SUBJECT: Forwards addl response to NRC 900910 request for addl info
 re emergency power sys enhancement project.

Re: Turkey Point Units 3 and 4
Docket No. 50-250 and 50-251
Emergency Power System Enhancement Project

RESPONSE TO NRC QUESTIONS
EDG BUS LOAD SEQUENCER

INPUT MODULE
TEST SETUP
FIGURE 1.

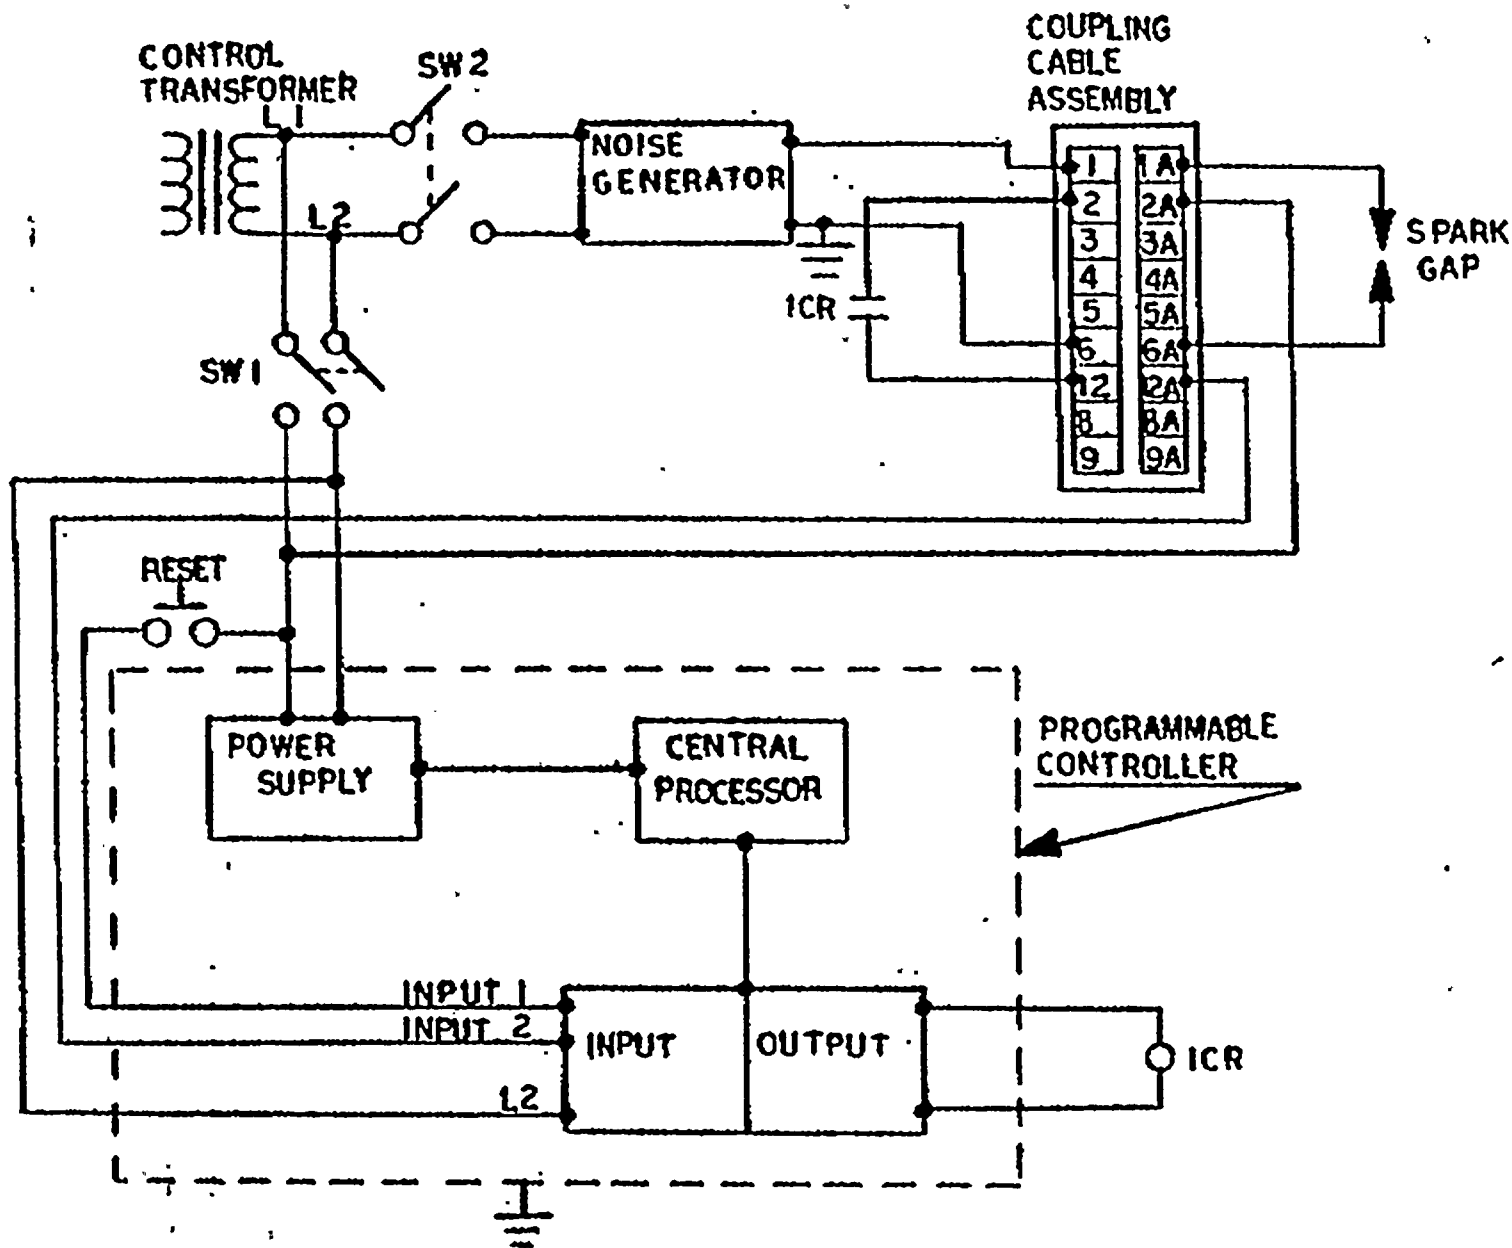
Provide a detailed description of the device(s) used to accomplish electrical isolation, and describe the specific testing performed to demonstrate that the device is acceptable for its application(s). This description should include elementary diagrams to indicate the test configuration and how the maximum credible faults were applied to the device(s).

Schemes for the noise test are included in Attachment 1. The surge test is performed by connecting a surge transient generator, through an isolation network, to the ac power supplied to the test PLC. The waveforms and other characteristics of the transients and surges are in accordance with IEEE 472 and NEMA ICS-1.

1. Figures 1 through 3, attached, provide the actual test schematic as performed by Allen-Bradley for signal noise on PLC input modules, output modules, and power supplies. The test transients applied meet the transient requirements specified in NEMA ICS-1.
2. Figure 4 shows the model test schematic as contained in IEEE 472/ANSI C37.90a.

OUTPUT MODULE
TEST SETUP
FIGURE 2.

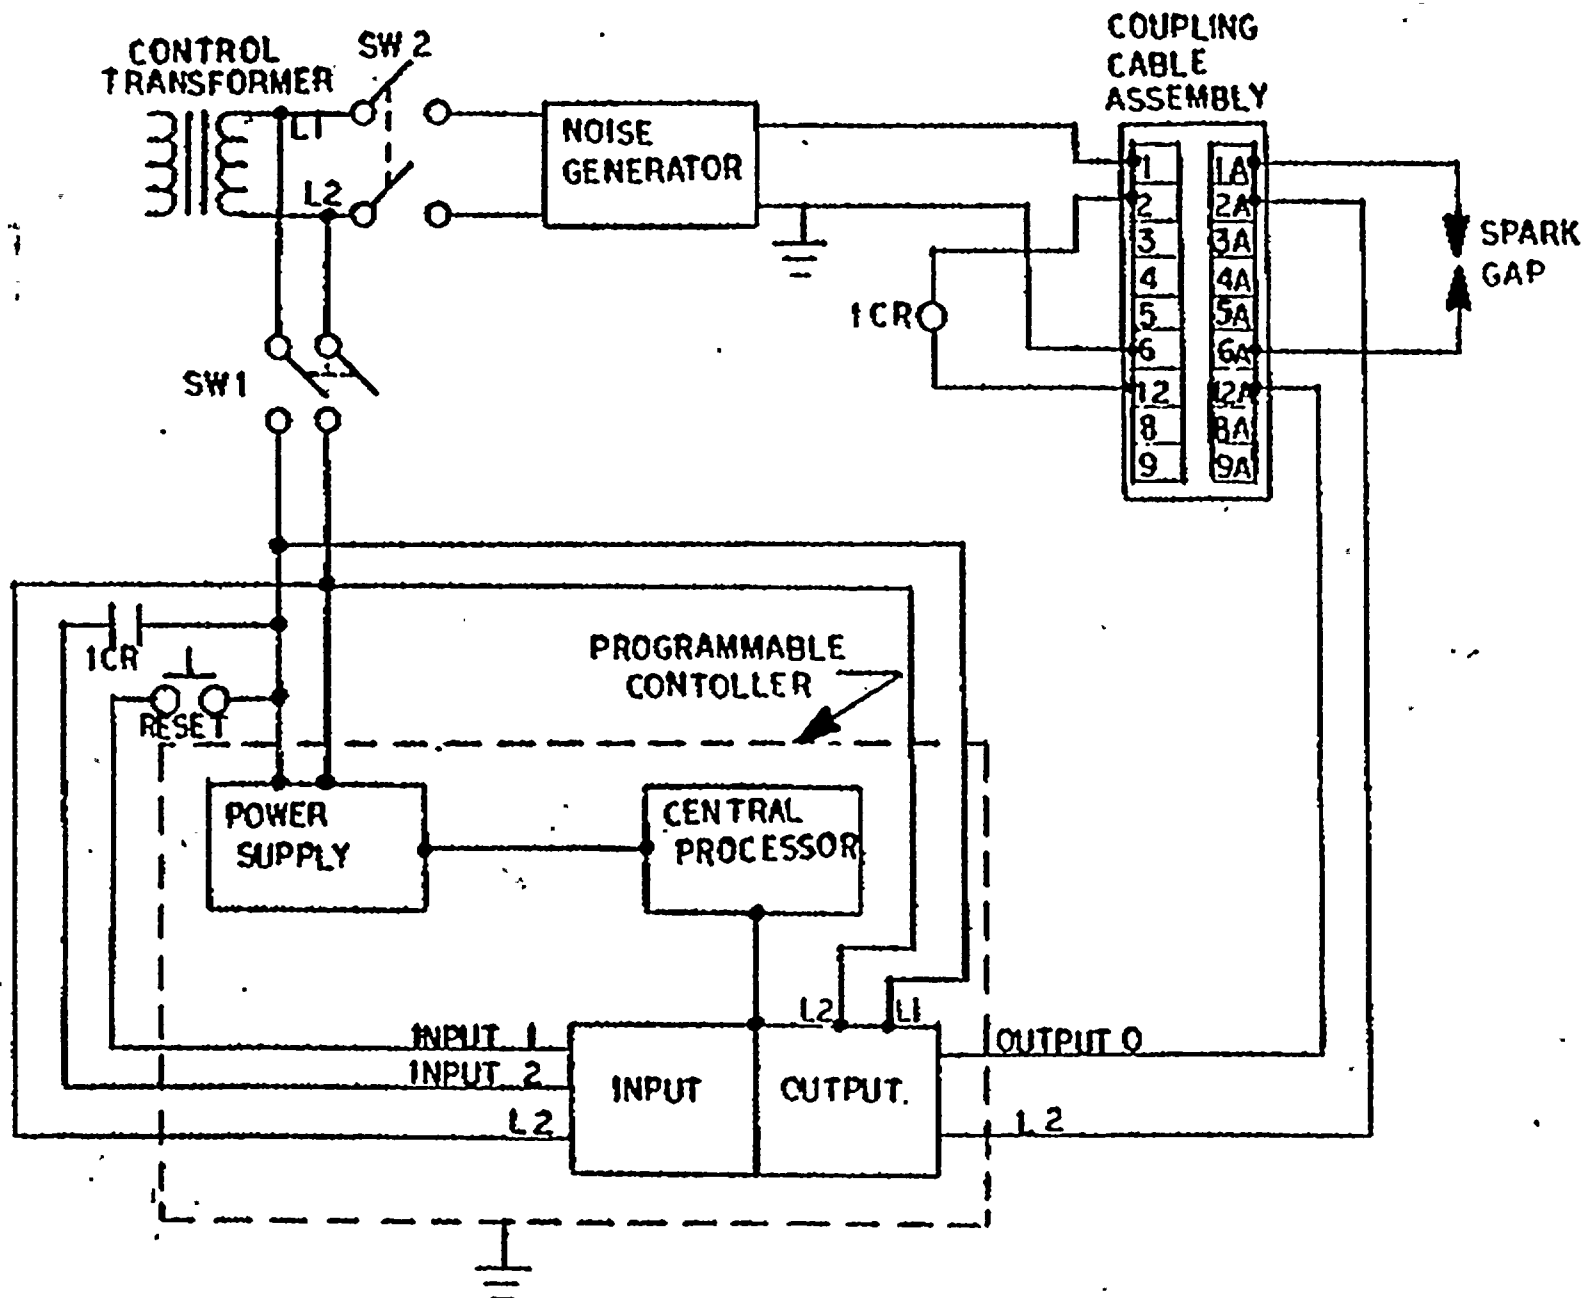
Provide data to verify that the maximum credible fault was applied to the output of the device in the transverse mode (between signal and return) and to verify that other faults were considered, i.e., open and short circuits.

In accordance with NEMA, ANSI, and IEEE standards mentioned in RAIs 1 and 2 above, transient voltages have been applied to the output modules to verify PLC resistance to voltage transients for normal throughput and transverse operating modes, as shown in Attachment 1. Open and short circuit faults simulate change of state of contacts which have been demonstrated through testing. Proprietary test data is maintained at the Allen-Bradley facility.

FIGURE 4

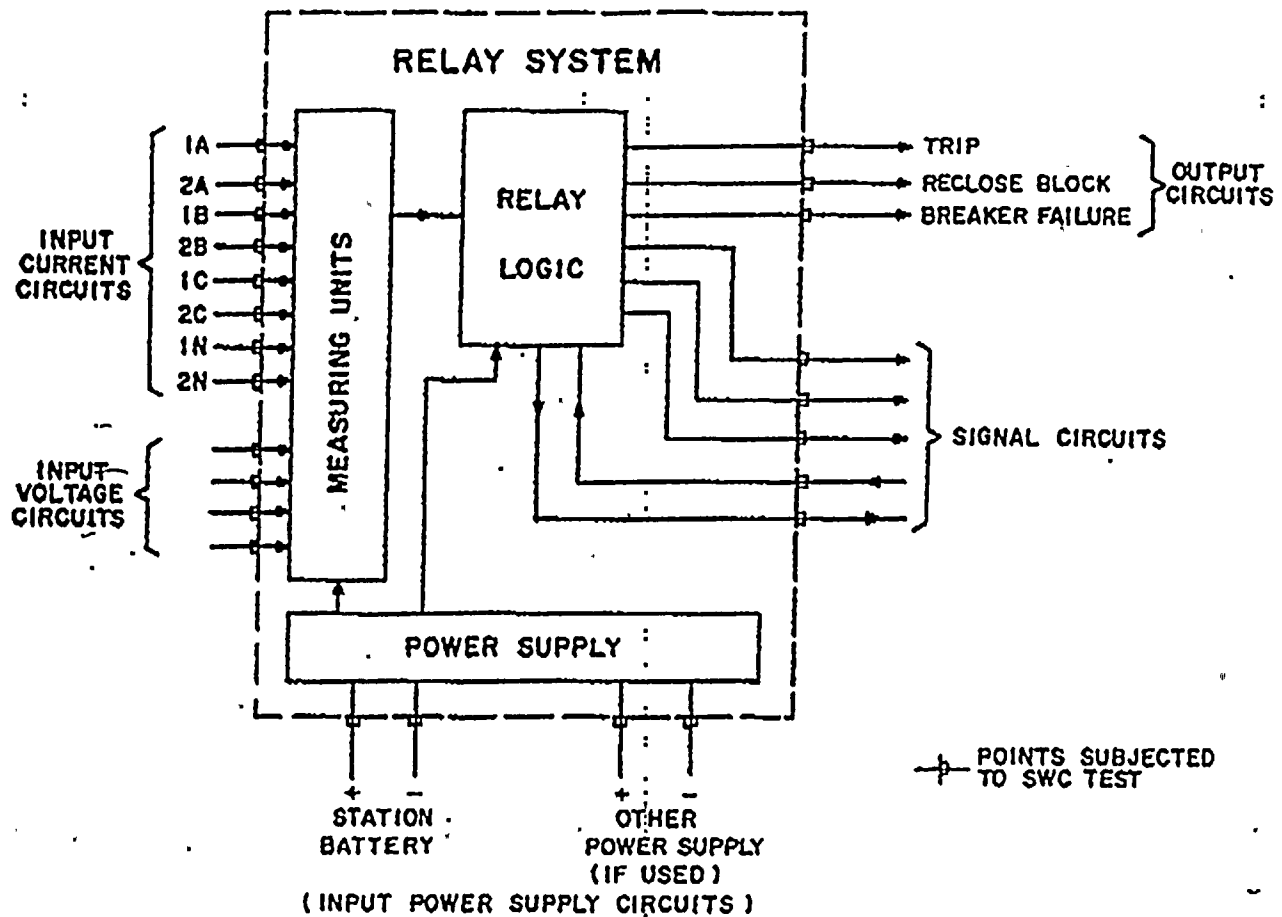
Provide data to verify that the maximum credible faults applied during the test were the maximum voltage/current to which the device could be exposed and define how the maximum voltage/current was determined.

- a) NEMA standard ICS 1-1983 for noise (for all control and ac lines supplying power to a power supply of a programmable logic controller).
- b) ANSI C37.90A-1974/IEEE standard 472-1974 - This standard provides a guide for ac surge withstand capability tests and requires a test wave in the range of 2.5-3.0 kV.
